**UTAH DIVISION OF RADIATION CONTROL
ENERGYSOLUTIONS CLIVE LLRW DISPOSAL FACILITY
LICENSE NO: UT2300249; RML #UT 2300249**

**CONDITION 35 COMPLIANCE REPORT; APPENDIX A:
FINAL REPORT FOR THE CLIVE DU PA MODEL**

**SAFETY EVALUATION REPORT
VOLUME 1**

April 2015

Figure 4-1 – Eh-activity diagram demonstrating uranium speciation and solubility in the absence of carbonate. Note that yellow regions indicate formation of a solid phase. Model generated using Geochemist Workbench and LLNL v8r6+ database.

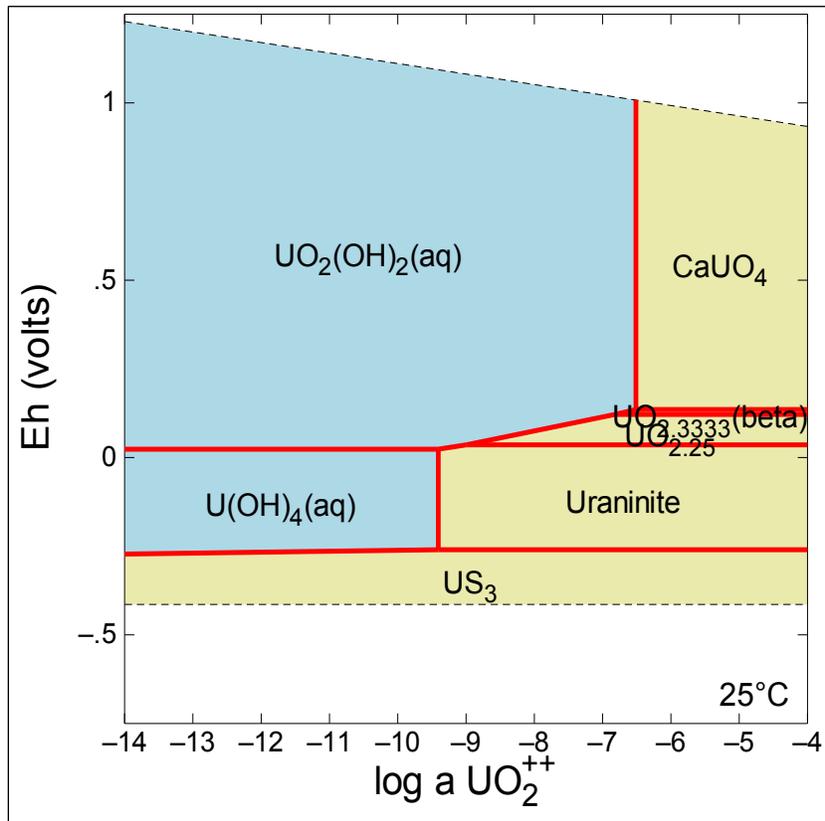
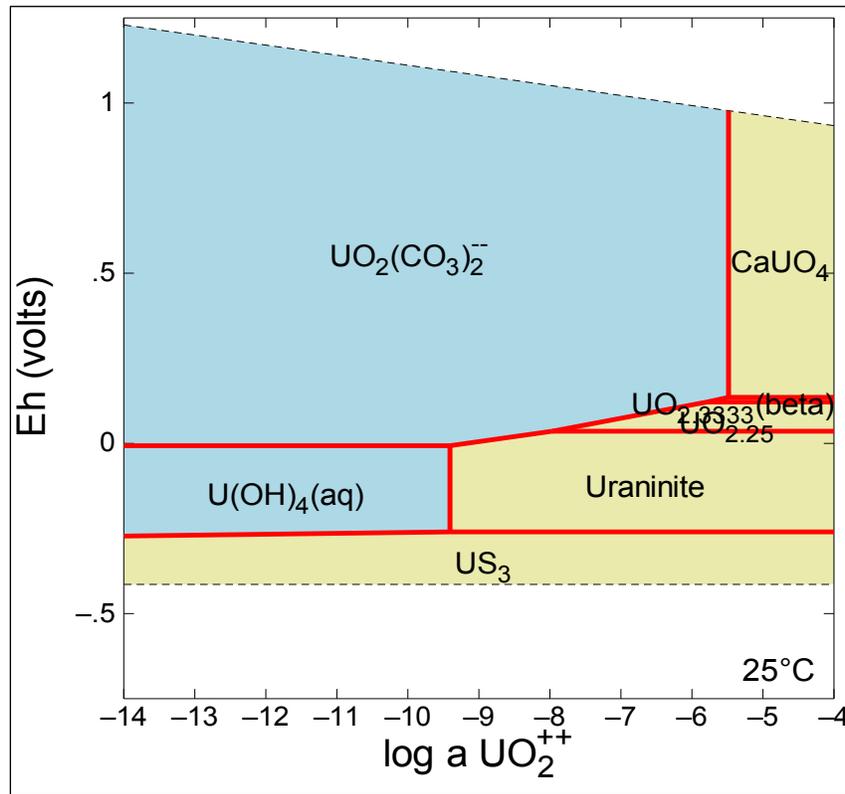
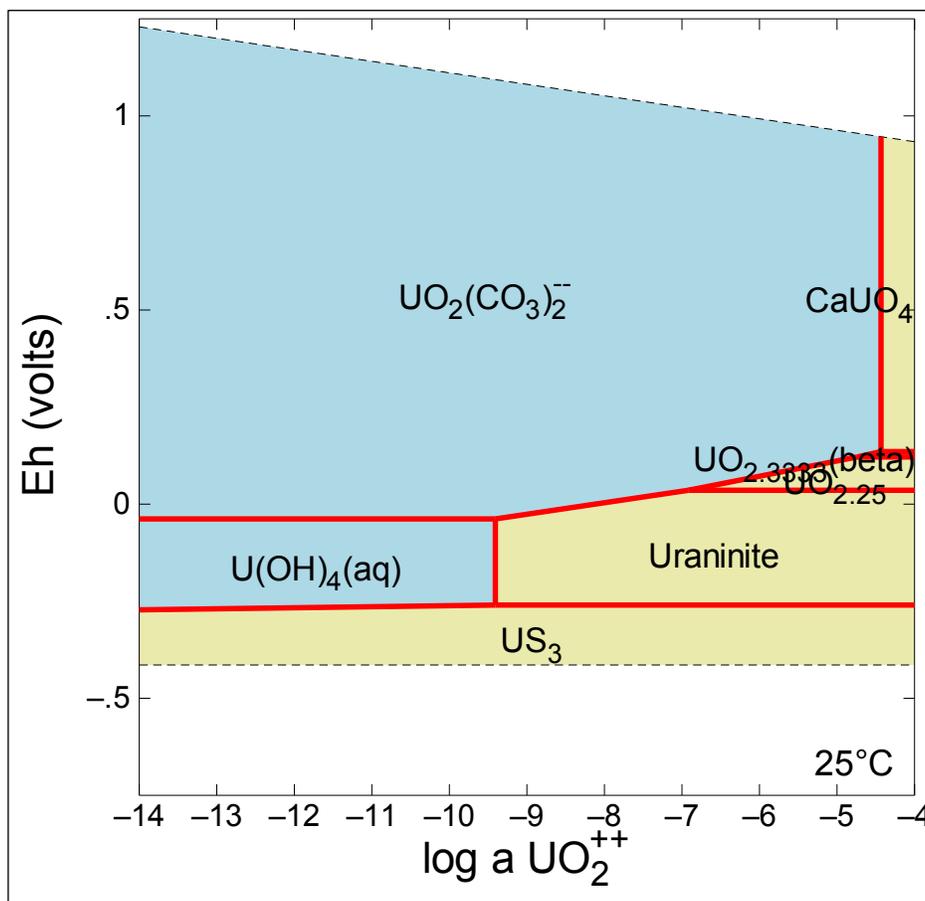
As part of the performance assessment review, DEQ's contractor generated the phase diagrams in Figure 4-1, Figure 4-2, and Figure 4-3 to illustrate the solubility of uranium versus redox potential in the presence and absence of carbonate using Geochemist Workbench with the Lawrence Livermore National Laboratory (LLNL) v8r6+ database. The diagrams were generated using the dissolved ion concentrations from Tables 8 and 12 in the geochemical modeling report (Appendix 6 to the DU PA, Neptune 2014m), with and without carbonate included and with the pH fixed at 7. The oxidation/reduction potential (E_H) and total uranium were varied, and the diagrams are shown in a pourbaix format with the dominant species shown in each region. Under reducing conditions, formation of tetravalent-state uranium [U(IV)] minerals limits the solubility of uranium through formation of an insoluble uraninite mineral phase. As can be seen in Figures 4-1 through 4-3 below, increased concentration of carbonate in an oxidizing groundwater environment encourages the dissolution of uranium due to formation of soluble uranyl carbonate complexes. This phenomenon has a bearing on performance assessment model assumptions for uranium fate and transport in the subsurface environment (the vadose and saturated zones).

In EnergySolutions’ response to Round 1 interrogatories (ES 2014d), the last line of Table 2-64/1 presents uranium solubility data from SNL 2007. The uranium concentrations reported in EnergySolutions’ Table 2-64/1 seem to only include the solubility of hexavalent-state uranium [U(VI)] and mixed U(IV/VI) phases and do not consider the potential formation of U(IV) phases [i.e., aqueous U(IV)(OH)_x^{4-x} species and U(IV) minerals such as uraninite]. Formation of uraninite will significantly decrease overall uranium solubility in groundwater. As noted in the Round 2 Interrogatory CR R313-25-8(4)(a)-64/2 (DRC 2014b), the DU PA needed to clarify whether the geochemical model considers the potential formation of uraninite or other U(IV) phases and the expected redox conditions of the waste in the landfill, because not considering the U(IV) phases if they are indeed forming will result in an overly conservatively high estimate of aqueous uranium concentrations, due to failure to consider aqueous uranium hydroxide [U(OH)₄].

Figure 4-4 – Comparison of redox coupled and uncoupled solubility models

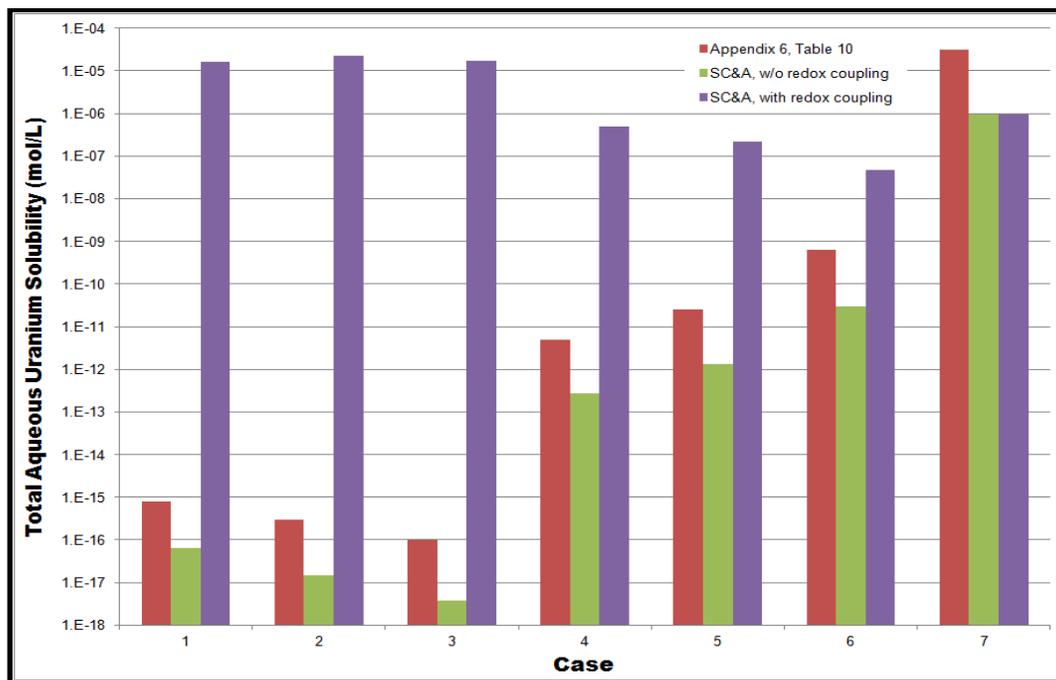
Also relevant to the overall prediction of the solubility of uranium is that the solubilities listed in Table 12 of the geochemical modeling report (Neptune 2014m) represent the output of a Visual MINTEQ model of triuranium octoxide (U₃O₈) solubility. Given the low solubilities of uranium reported in Table 12, it is clear that oxidation of U(IV) to U(VI) was not considered. This must be done by “coupling” the U(IV)/U(VI) reaction within Visual MINTEQ before running the

model. It appears that the intent of the modeling exercises examining schoepite¹¹ and U₃O₈ solubility in Tables 9 through 12 of the geochemical modeling report (Neptune 2014m) was to give the boundaries of uranium solubility. However, it is unrealistic to run a model with a relatively high E_H/pH condition (such as pH 8, E_H 200 millivolts in Table 10) and not allow for the oxidation of reduced species. Therefore, the Round 2 Interrogatory CR R313-25-8(4)(a)-64/2 expressed a concern about whether the reported low-solubility values in EnergySolutions Table 12 are reliable for use as the source term in reactive transport models. Figure 4-4 and Table 4-2 show the reported values from EnergySolutions Table 12 as well as two columns of output from additional DEQ Visual MINTEQ runs. As part of the DU PA review, DEQ used the average ion concentrations in the last row of Table 8 in conjunction with the data in Table 12 of the geochemical modeling report (Neptune 2014m) in an attempt to reproduce the reported total dissolved uranium concentrations shown in Table 12. This was done by running the model with the U(IV)/U(VI) system uncoupled, as was apparently done for the model output shown in Table 12. However, the final column in Table 4-2 shows the total uranium concentration in a Visual MINTEQ model with the U(IV)/U(VI) reaction coupled. Oxidation of U(IV) to U(VI) is therefore allowed, and the expected total dissolved uranium concentrations are significantly higher. Because the redox chemistry of the waste disposal site in this work is variable, DEQ recommended in the Round 2 interrogatory CR R313-25-8(4)(a)-64/2 (DRC 2014b) that redox-coupled solubility calculations be used when defining the source concentrations in reactive transport models. The specific E_H and pH ranges expected under the various geologic conditions considered in the reactive transport models must be used in this source term analysis.
